RE: City of Hickory (Plaintiff) vs. Neill Grading and Construction Company, Inc., Dane Construction, Inc., and Western Wood Structures, Inc.
Preliminary Report – **Attorney Work Product**
CASE #: 22-CVS-804 (North Carolina, Catawba County, Superior Court)
FORCON CASE #: NC22003-1

As Counsel for Neill Grading and Construction Company, Inc. (Neill), you have requested that I (Dara Thomas, P.E., a FORCON International Corporation (FORCON) Professional Forensic Structural Engineer), provide services as an Expert and prepare a Preliminary Report on this matter. **The purpose of the report is to express my opinions, to-date, about the catastrophic failure of the Iconic Arches at the City Walk Project, Hickory, NC.**

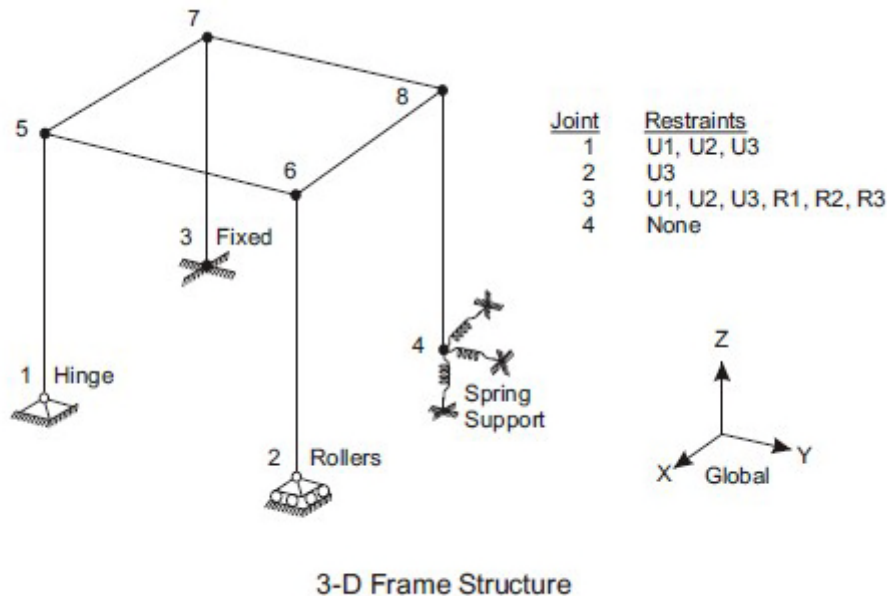
An obvious choice to utilize available components for bracing is to have designed all eight base plate – foundation connections to resist lateral load. In order to do this, the joints at these locations would have to intentionally be designed in the computer model as a *fixed connection* rather than a *pinned connection*. A fixed connection would prevent displacement in all six degrees of freedom. Whereas the Western Wood computer model allowed rotation about the base plate nodes (marked the three rotational degrees of freedom as *unrestrained instead of restrained*). To do this, a moment-connection would have to be accomplished. This would likely mean a heavy-duty steel sleeve around the GluLam timbers with multiple large diameter anchor bolts into the concrete. The connection at the base plate nodes would have to eliminate not only movement side-to-side but eliminate any rotation of the structure around the connection. We know that the base plate connections were not fixed connections because of the choices made in the computer program. Following is a diagram depicting a fixed node vs. a pinned (hinged) node:

As we can see from the diagram, in order to create a *fixed* node (node 3 in the diagram) in the frame analysis computer model, we must restrain all six degrees of freedom. And we can see in the calculations from Western Wood that the EOR of the timber structure only restrained the x, y, and z movements (U1, U2, U3). The rotation degrees of freedom (R1, R2, R3) were not restrained in the computer model by Western Wood. This means that the eight base plates were allowed to freely pivot/rotate once the arches began to fall over. They offered no assistance in resisting the collapse.

Photograph 18) – Part S15. This would have been connected to the lower part of the arch. It pulled apart from the piece shown in Photo 14.

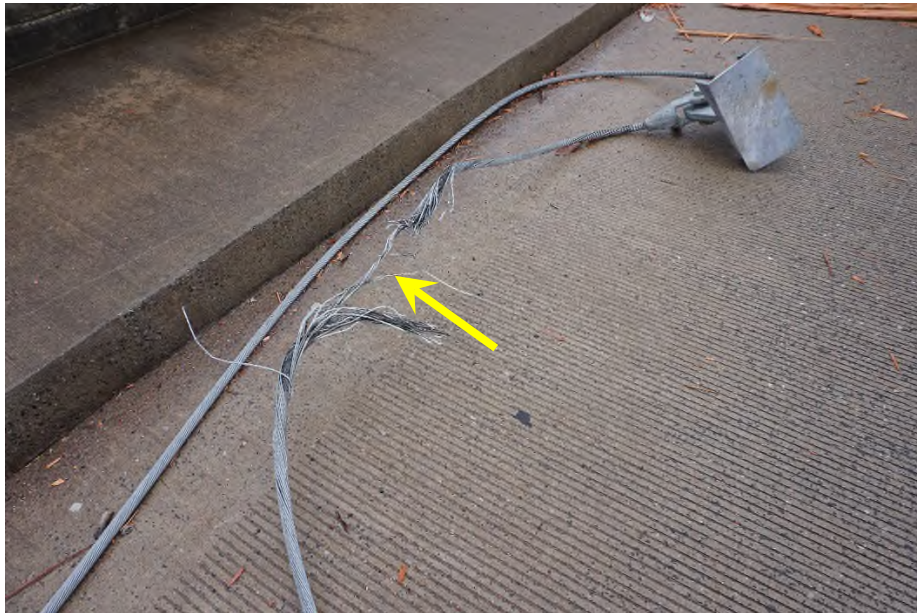
5. **Regarding the cable connector steel bracket S15 (shown in the Western Wood shop drawings), which pulled apart at a welded joint, I could not locate any calculations of the required weld size or length. There is no indication that the welds were designed at all for the reaction forces.**

There is evidence to suggest that the guy cables were over-stressed, as one of them was nearly pulled apart due to tension. But before it snapped completely, the connector Mark S15 came apart at the welds. This cable situation most likely also suffered due to the P-Delta effect. The dead weight causing additional twisting load to the north likely overcame the cable and connection design and it failed. Once that happened, lateral forces were then transferred to nodes 4 and 22. Once those connections began to come apart, the twisting load to the north was transferred to the base plates, which were not designed to resist such twisting moment. We know this because they were defined in the computer model analysis as *pinned connections*.
